5020 N. INTERSTATE

APPLICANT APPEAL 1

NEIGHBORHOOD APPEAL

SOUTH UNIT PORCH PLAN

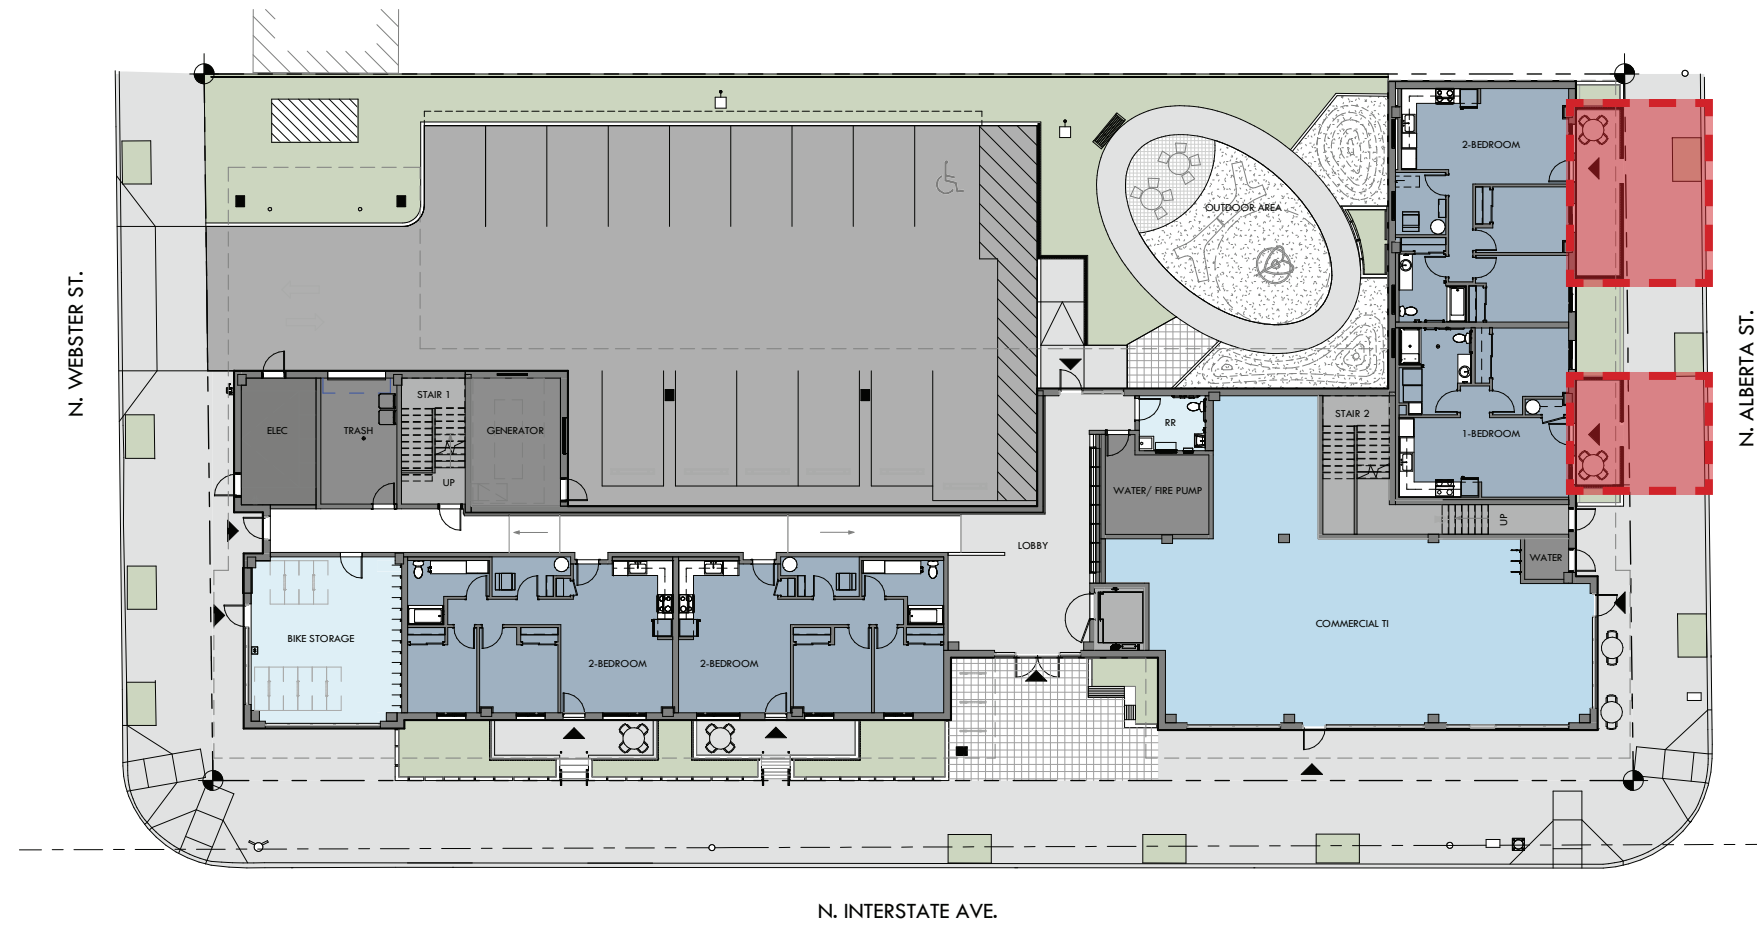
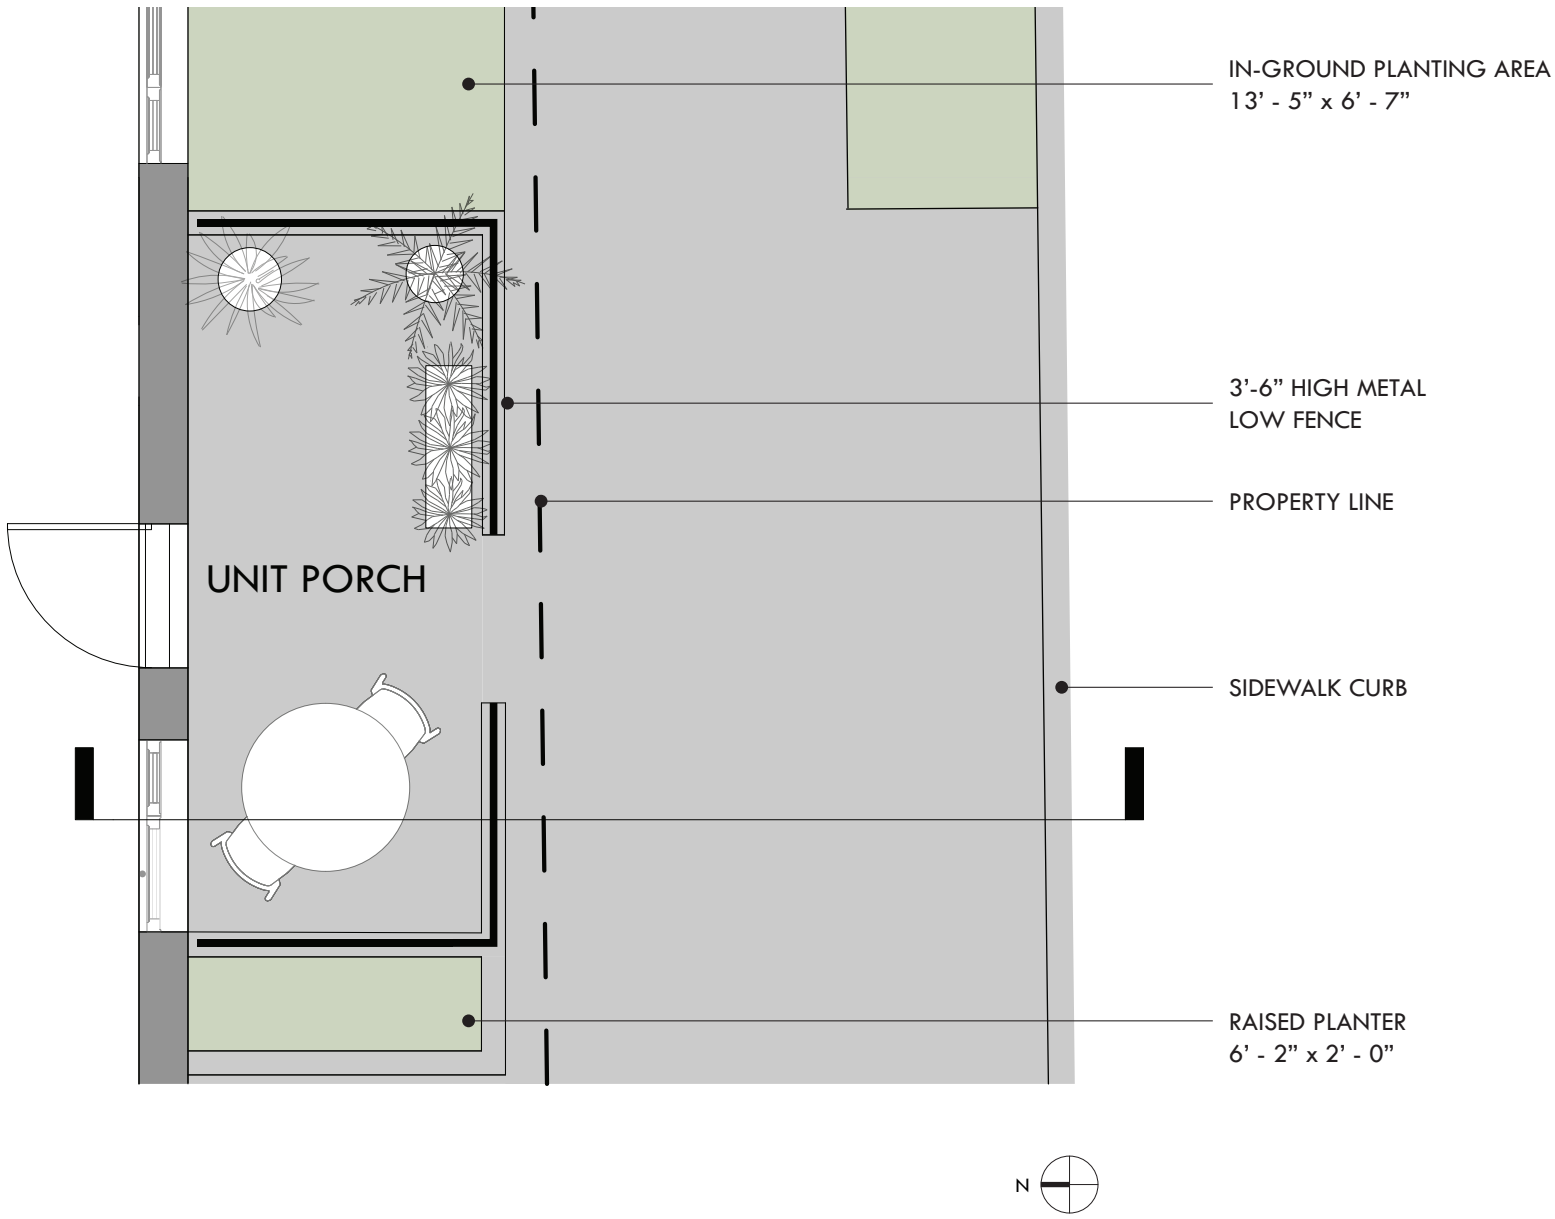
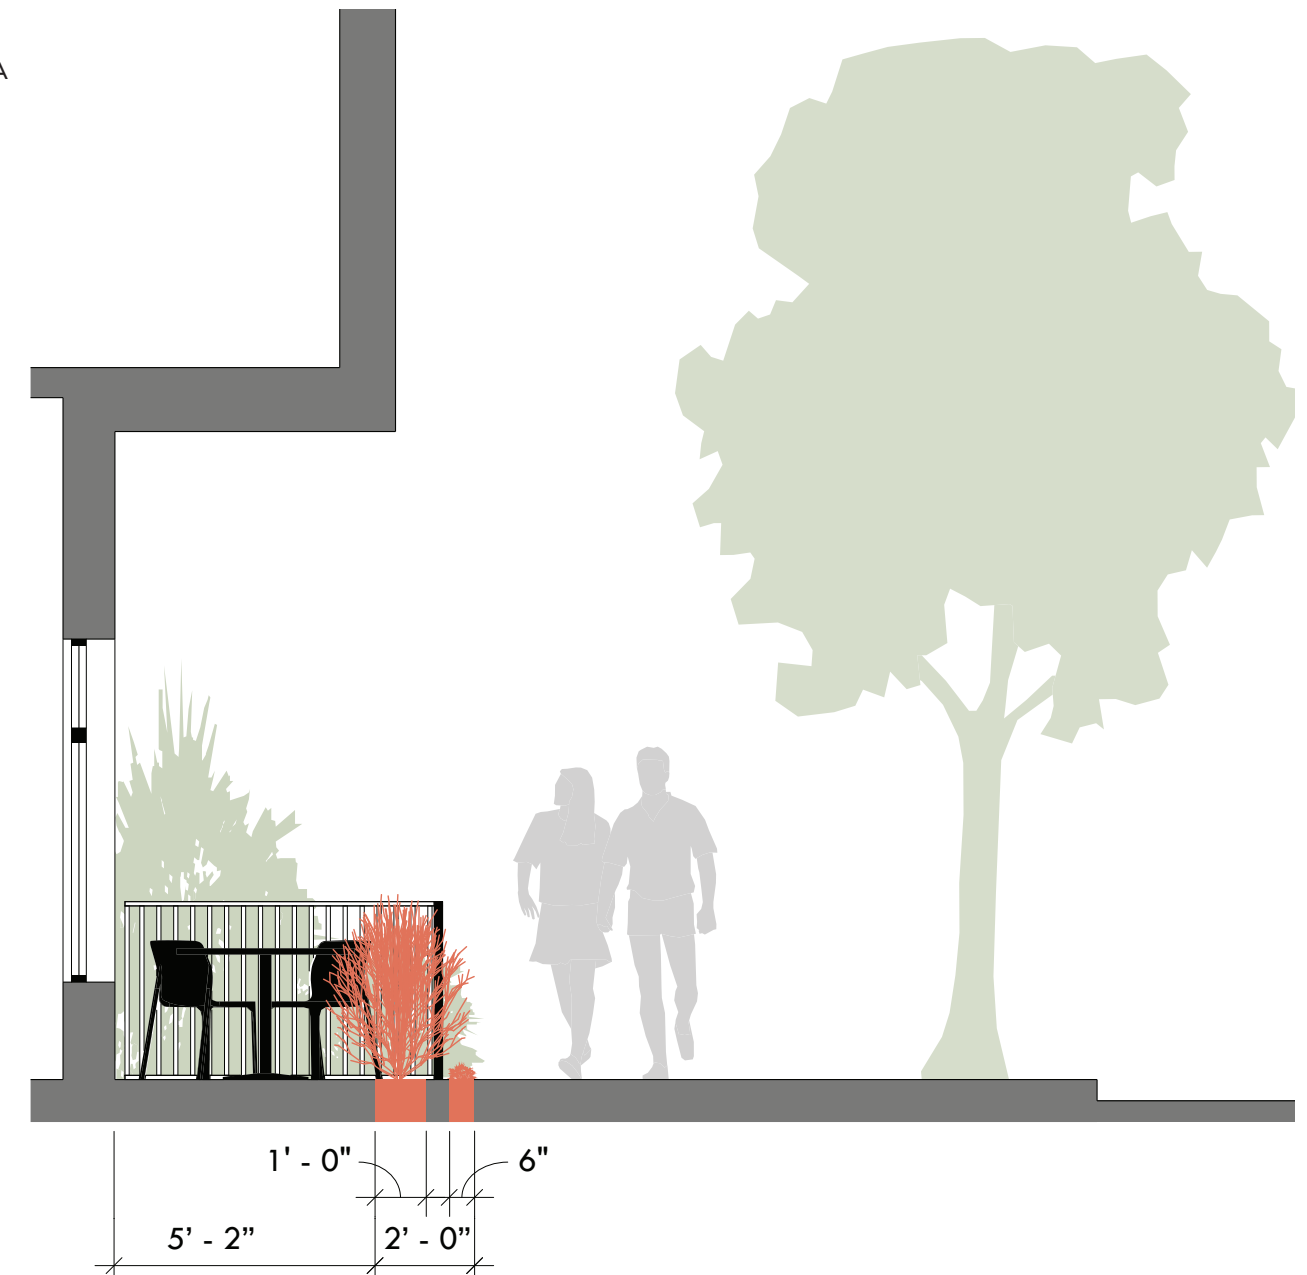
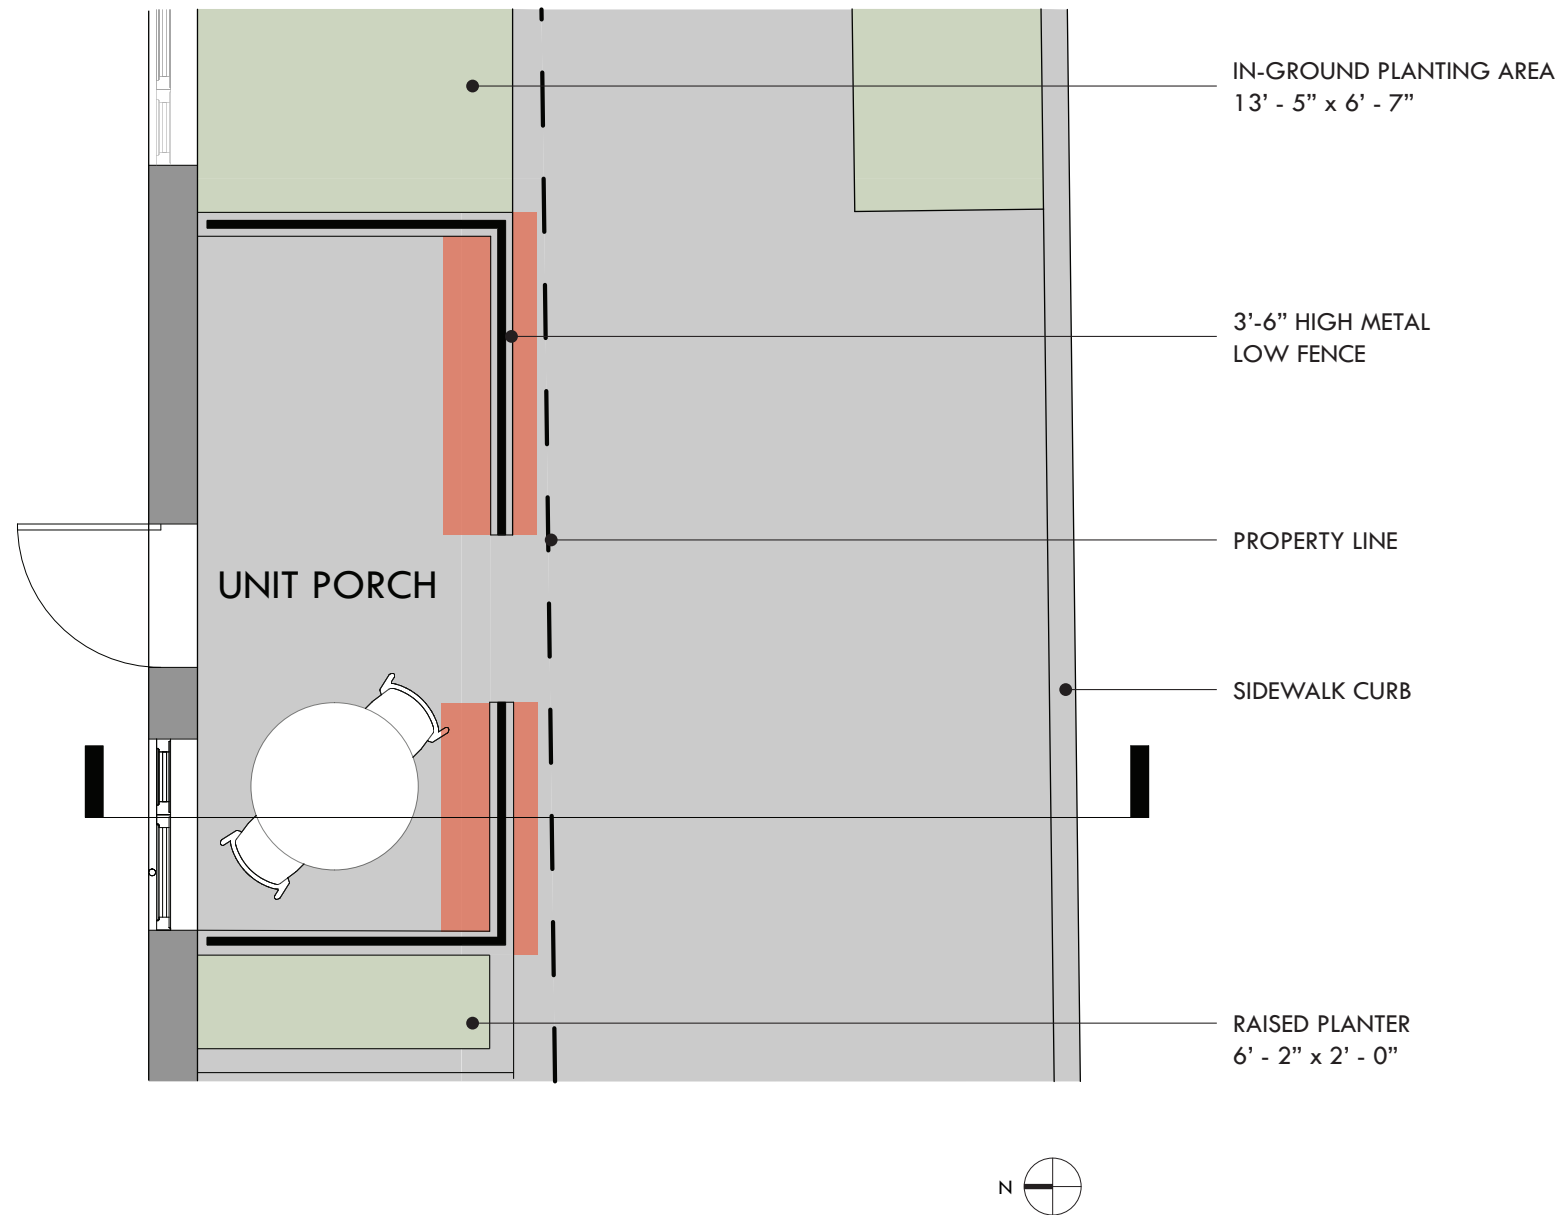
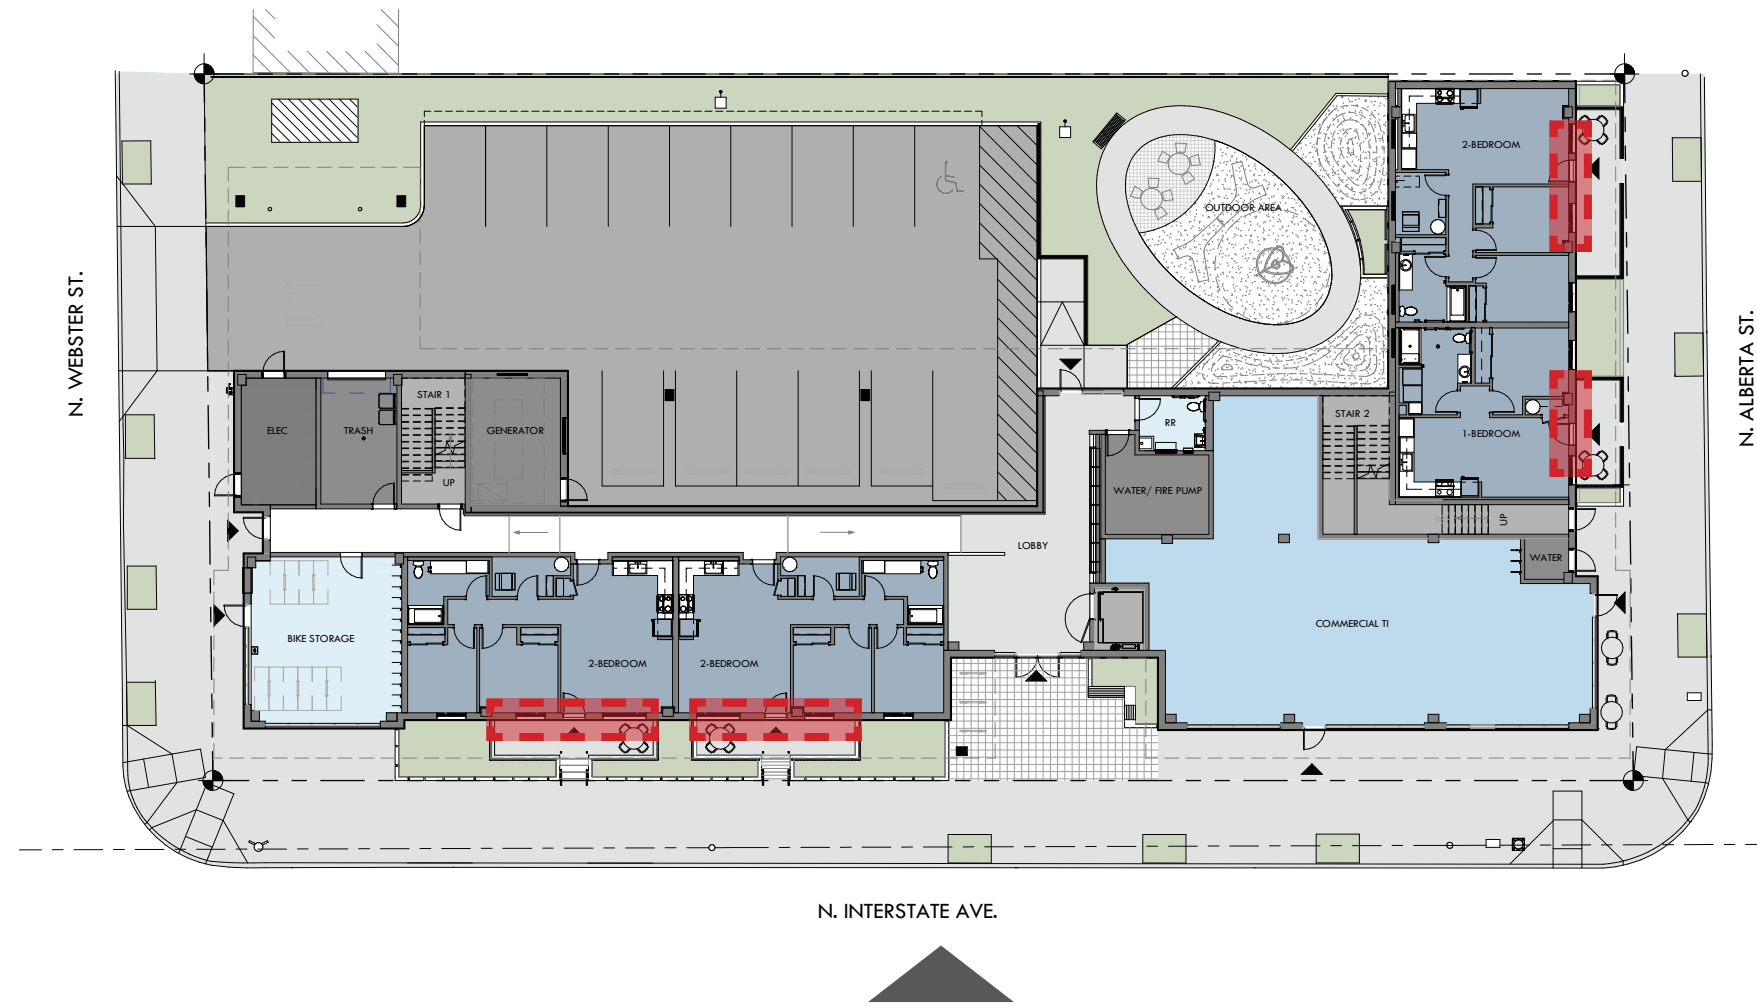
CONDITION OF APPROVAL 2

“ADDITIONAL IN-GROUND LANDSCAPE PLANTERS, RUNNING FOR THE LENGTH OF THE LOW FENCES, EXCEPTING SPACE FOR ENTRIES, AND AT LEAST 18 INCHES IN WIDTH, SHALL BE PLACED AT THE RESIDENTIAL PATIOS ALONG N. ALBERTA ST. AT LEAST 6 INCHES OF THIS SPACE SHOULD BE LOCATED ON THE SIDEWALK SIDE OF THE FENCES AND PLANTED WITH GROUND COVERS, GRASSES, OR FLOWERING PLANTS, AND AT LEAST 12 INCHES SHOULD BE ON THE PATIO SIDE OF THE FENCES AND PLANTED WITH EVERGREEN SHRUBS THAT WILL GROW AS TALL AS THE FENCE ITSELF.”

-  PLANTING AREA
-  CONDITION OF APPROVAL REQ'D ADDITIONAL PLANTING AREAS

- DEPTH OF PORCHES SIZED TO BE USEABLE BY RESIDENTS AND ALLOW FOR FURNISHINGS AND PLANTS, ETC.

- VIABILITY OF PLANTINGS QUESTIONABLE WITH NARROW PLANTING STRIPS WHERE IRRIGATION CANNOT BE INSTALLED AND LOCATION ALONG PUBLIC SIDEWALK
- PLANTINGS REDUCE USEABLE DEPTH OF PORCHES, AND FLEXIBILITY FOR RESIDENTS TO PROVIDE THEIR OWN PLANTERS AND FURNISHINGS
